Staff Report – Plan Commission

Docket #:	PC2024-018	Hearing Date:	July 22, 2024
Applicant:	Chris Strack, SCS Construction Services, 173 E. Broadway St, Ste. 100, Greenwood		
Owner:	CJS Greenwood, LLC, 200 S. Biscayne Blvd. FL 7, Miami, FL 33131		
Subject Property:	532 N. State Road 135, Greenwood		
Staff Contact:	Gabe Nelson, nelsong@greenwood.in.gov, 317.887.5230

Project Jiffy Lube Subdivision

SCALE: 1" = 10'	DESIGN BY: AB	CHECKED BY: SB	CORRECTED BY: ANDREW BARKOCY
DATE:	REVISION:	PROJECT NAME: JIFFY LUBE BUILDING EXPANSION 532 N. STATE ROAD 135, GREENWOOD, IN	
		SHEET NAME: WAVIER SITE PLAN	
		PREPARED FOR: SCS CONSTRUCTION 173 E. BROADWAY STREET GREENWOOD, IN 46143	
SHEET 1		DATE JUNE 19, 2024	
		JOB NO. 2574-WAIVERS

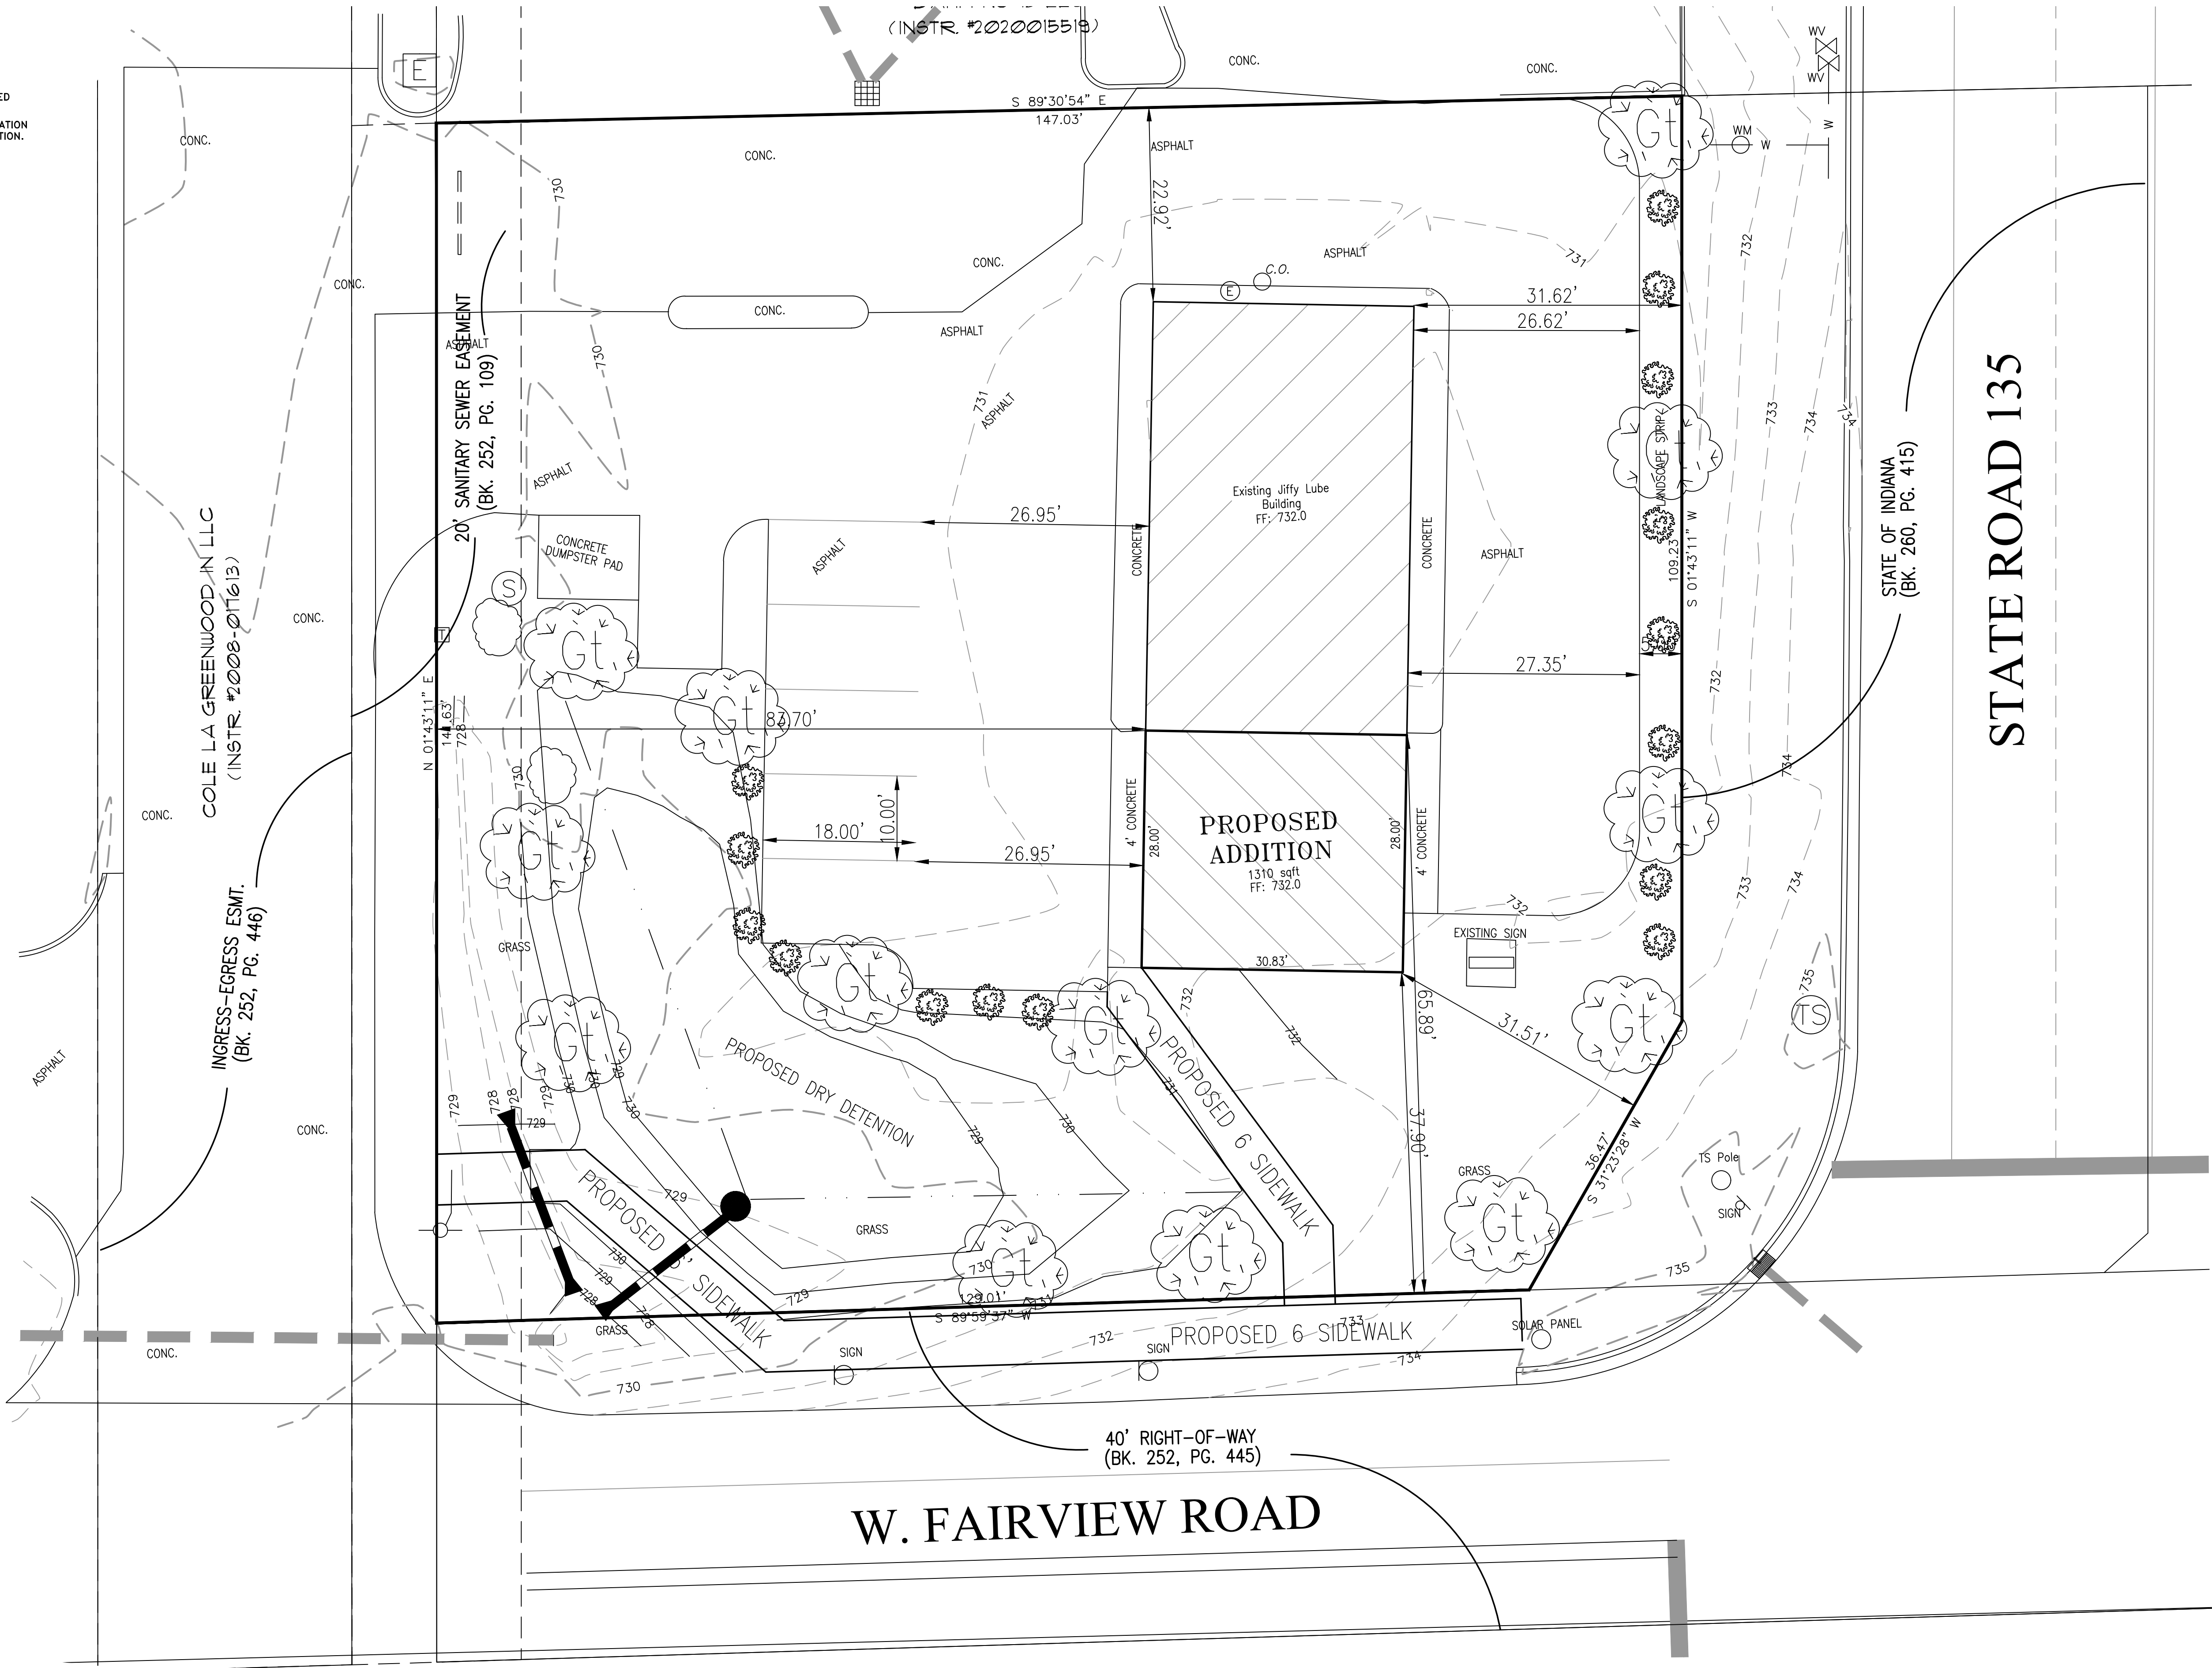
Jiffy Lube requests a landscape waiver from Sec 10-03-06 (J)(2)(d) – Perimeter Parking Lot Landscaping. Beyond the 5-foot wide landscaped area, when abutting a Primary or Secondary Arterial, an additional buffer area 10 feet in width must be given between the parking lot landscaping and the edge of the right-of-way. Petitioner requests to waive the additional 10 feet of buffer area due to site restrictions. Petitioner will provide a 5-foot wide landscaped area as required by the UDO.

Staff **recommends approval** of Sec 10-03-06 (J)(2)(d) – Perimeter Parking Lot Landscaping. Staff finds this achieves the desired landscaping intent and quantity. In addition, there is approximately 18 feet of greenspace acting as a buffer in the State Road 135 right-of-way that is not expected to be modified at any point in the near future, with the possible exception of a sidewalk/path.

The Request is to eliminate the additional 10 foot wide greenspace area. Due to the proximity of the existing building to the existing right-of-way of State Road 135, there is not enough space to provide the extra 10 feet of green space to allow vehicles to safely and easily turn out of the building. The Crew Car Wash to the North has neither a 10 foot green space or the required 5' perimeter landscaping buffer. The curbing for Crew Car Wash is along the Right-of-way of State Road 135. The site is still proposing the 5' landscape buffer.

The requirement of an additional 10 foot landscape buffer would reduce the drive area from the garage doors and would not allow vehicles to make safe turns out of the building. The building is in an existing location and therefore there is only a certain amount of area between the building and the right-of-way. The proposed site is proposing to cut some of the existing drive out to provide a perimeter parking landscape buffer that is required.

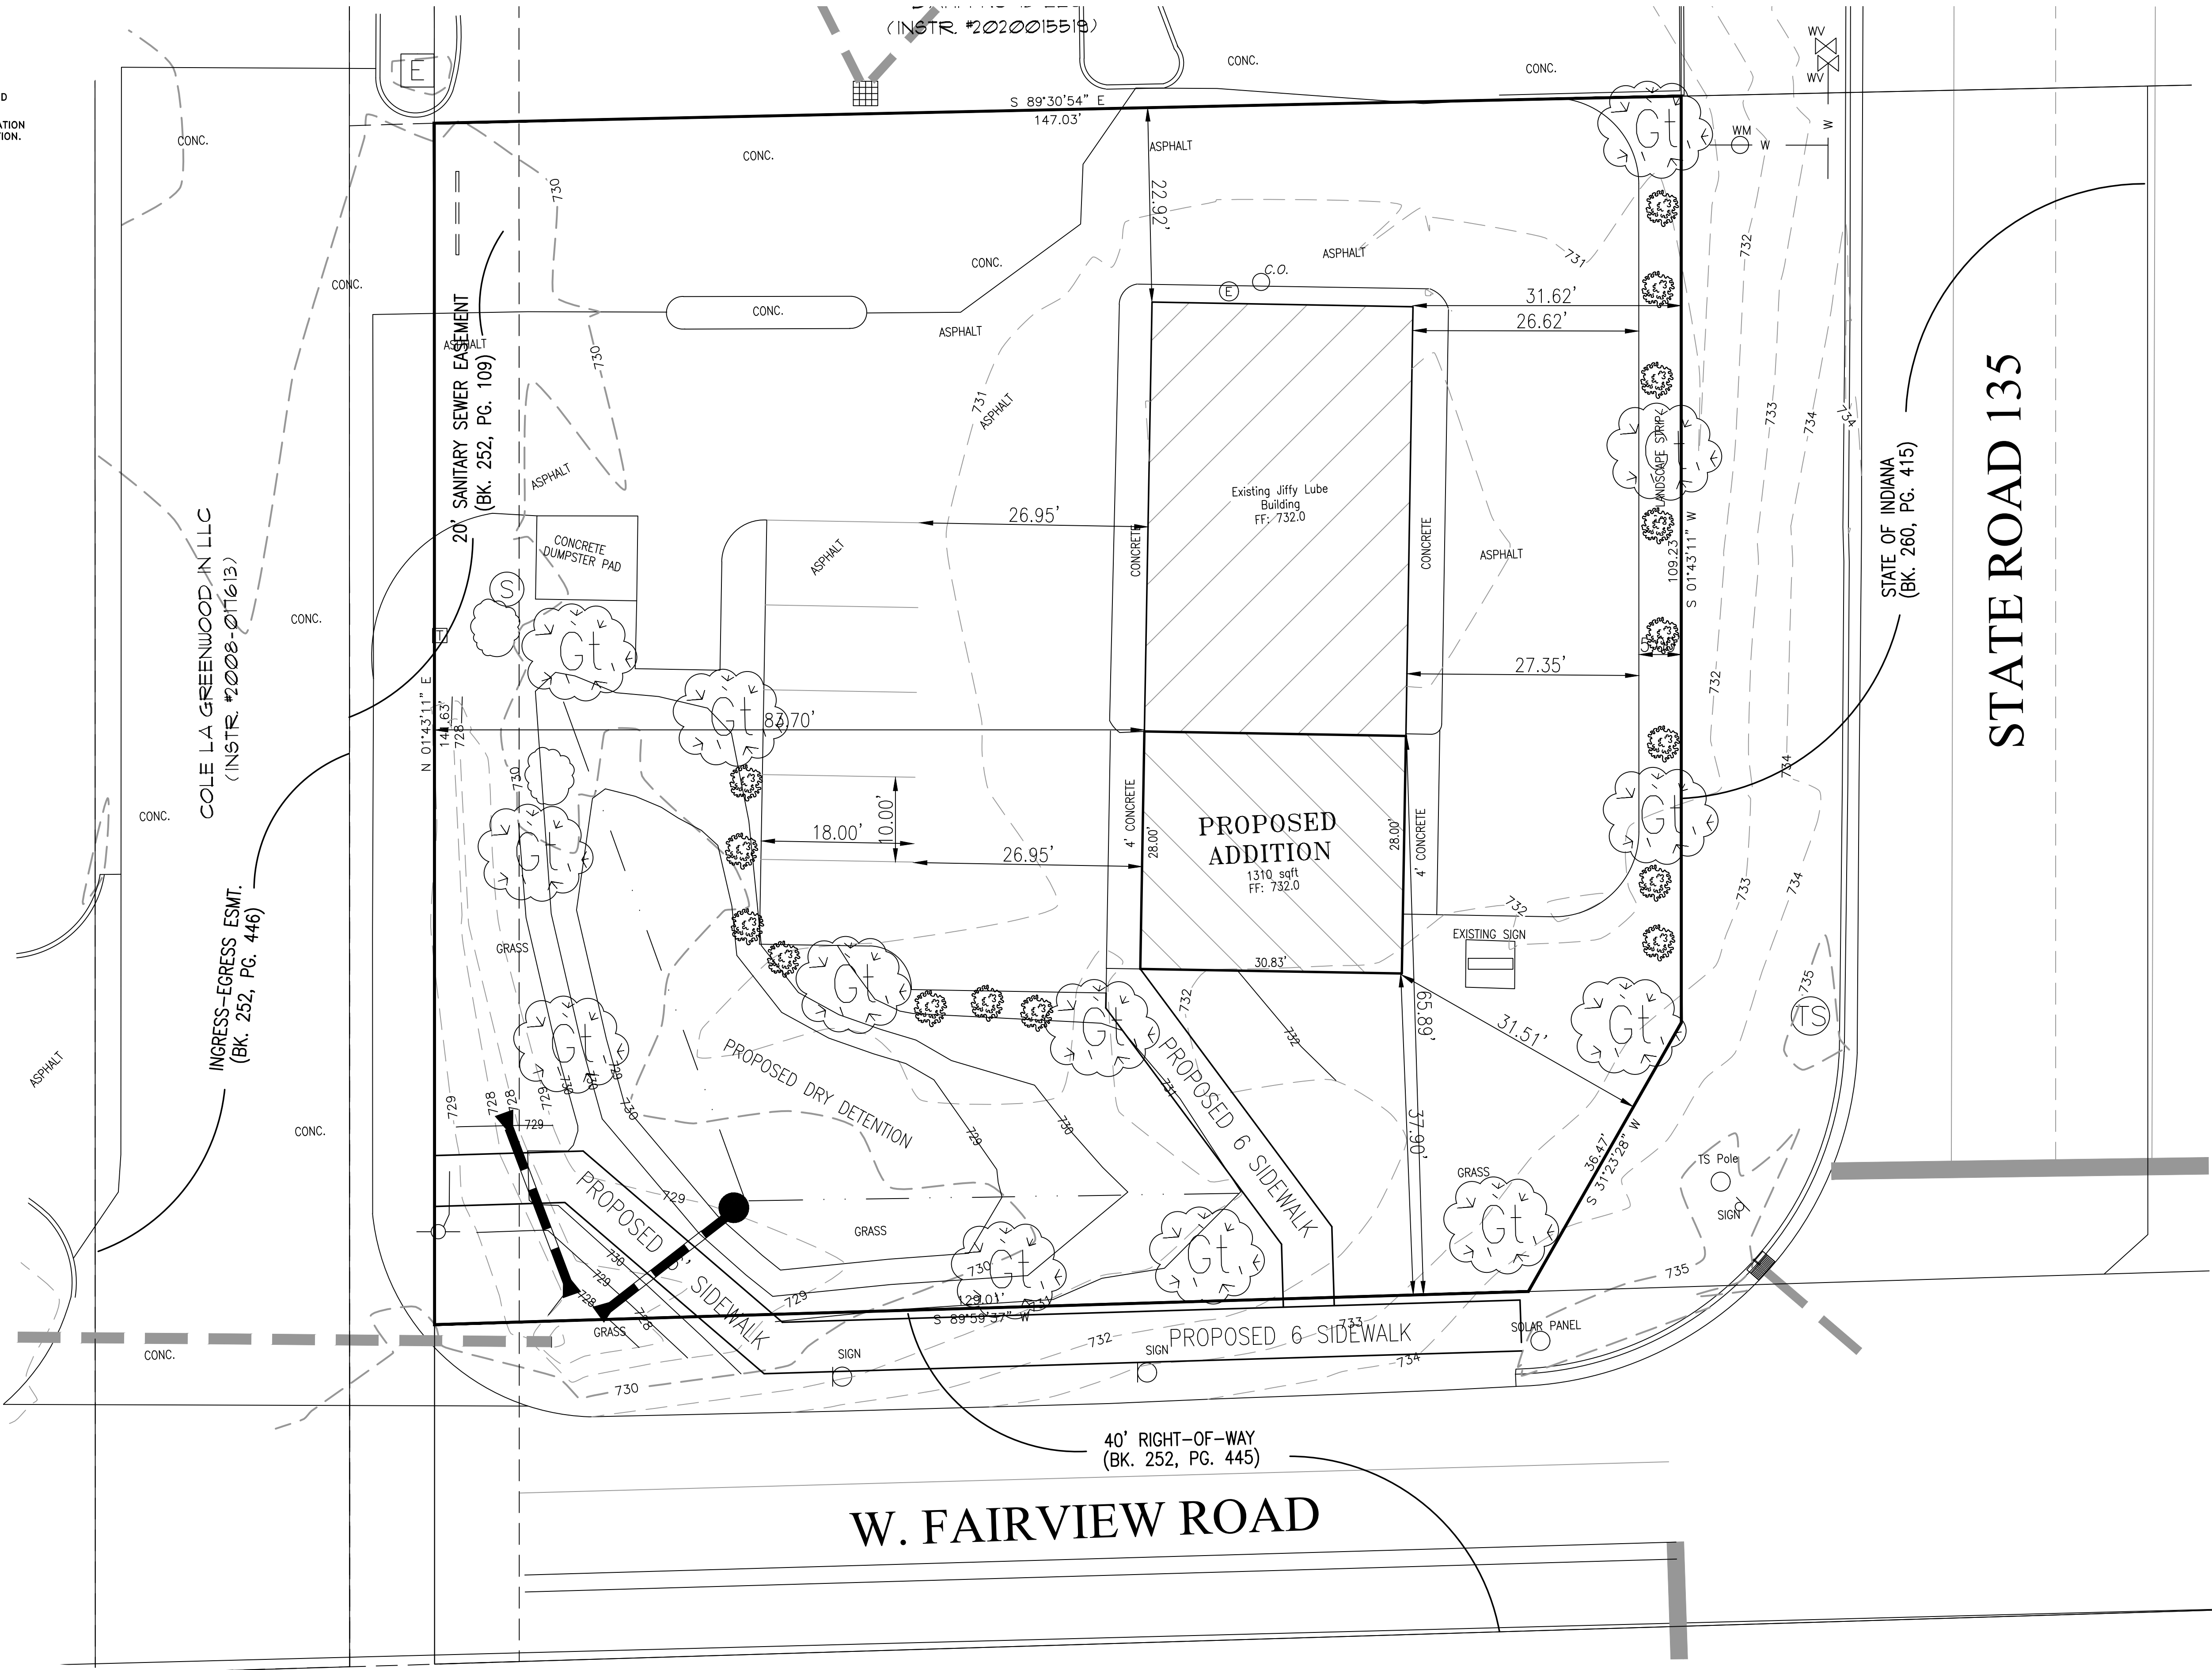
Jiffy Lube requests a landscape waiver from Sec 10-06-09 (A) – Required sidewalks in subdivisions. A 6-foot sidewalk is required in and along commercial subdivisions. Petitioner requests to waive the sidewalk requirement only along State Road 135. Sidewalk will be installed along W. Fairview Road.

Staff **recommends denial** of Sec 10-06-09 (A) – Required sidewalks in subdivisions. It would be preferred for the sidewalk to be placed in right-of-way, but this particular right-of-way is controlled by INDOT and they are refusing a sidewalk be placed there. However, Staff feels that there is sufficient room to install a 6-foot sidewalk inside the property line on State Road 135 and still provide adequate space for vehicles to turn left from the building. Proposed plans show a minimum of 26.6 feet for traffic exiting the building which would still leave at least 20 feet of pavement for turning with a 6-foot sidewalk. The City Engineer may reduce the width of the sidewalk due to slope, grade, topography, or other restrictions encountered in the field if space is a concern.

The Request is to eliminate the 6 foot wide sidewalk. Due to the proximity of the existing building to the existing right-of-way of State Road 135, there is not enough space to provide the required 5' perimeter parking landscaping and a side walk and still allow vehicles to safely and easily turn out of the building. The right-of-way is also INDOT's which they do not typically care for sidewalks in their right-of-way unless it is their sidewalk. Discussions have been made with them and they have also stated due to the location and terrain, they would prefer it to not be in their right-of-way and to request a waiver. The slope of the ground from the curb of State Road 135 to the site is around 19% which means if a sidewalk was to be constructed in INDOT's right-of-way some kind of retaining wall would need to be constructed which again INDOT was not in favor of. The curbing for Crew Car Wash to the North is along the right-of-way of State Road 135 and has no sidewalk either. The site is proposing a 6 foot wide sidewalk along Fairview.

The requirement of a 6 foot wide sidewalk along State Road 135 results in a practical difficulty in the development because the right-of-way is INDOT's and they would not prefer a sidewalk in this right-of-way area due to the steep slope of the ground within right-of-way. The building is in an existing location and therefore there is only a certain amount of area between the building and the right-of-way and for the site to get the 5 foot perimeter landscape buffer and a 6 foot sidewalk would not allow for safe exit for vehicles to leave the building. If the sidewalk was installed on the site along the right-of-way it would also line up with a drive lane of Crew Car Wash which could cause unsafe crossing of pedestrians and vehicles. The site is proposing to install a sidewalk along Fairview.

After speaking with our Special Projects Engineer, it is determined that it would be preferred if you were to ask for a waiver through the city first. Using the owners property is preferred, but INDOT does allow sidewalks in ROW if there isn't another option. From reviewing the plans it looks like you have another option. INDOT engineering's concern on placing the sidewalk in the Right of Way is that you would need to put in retaining walls to deal with the change in elevation.

"The applicant looks to be removing 10' of existing asphalt in their load out area that would be a very flat spot for the sidewalk as opposed to the slope that would be in the INDOT ROW. Is there a reason they wouldn't use this space for a sidewalk instead?"

You are correct we are looking at removing 10' to allow for a landscape buffer which is another requirement of the City. Yes it is also a much better location of the sidewalk but would require a waiver from the City since the landscape depth would be smaller with a sidewalk there. However, if INDOT is against the location of the sidewalk in their right of way we will proceed that way.
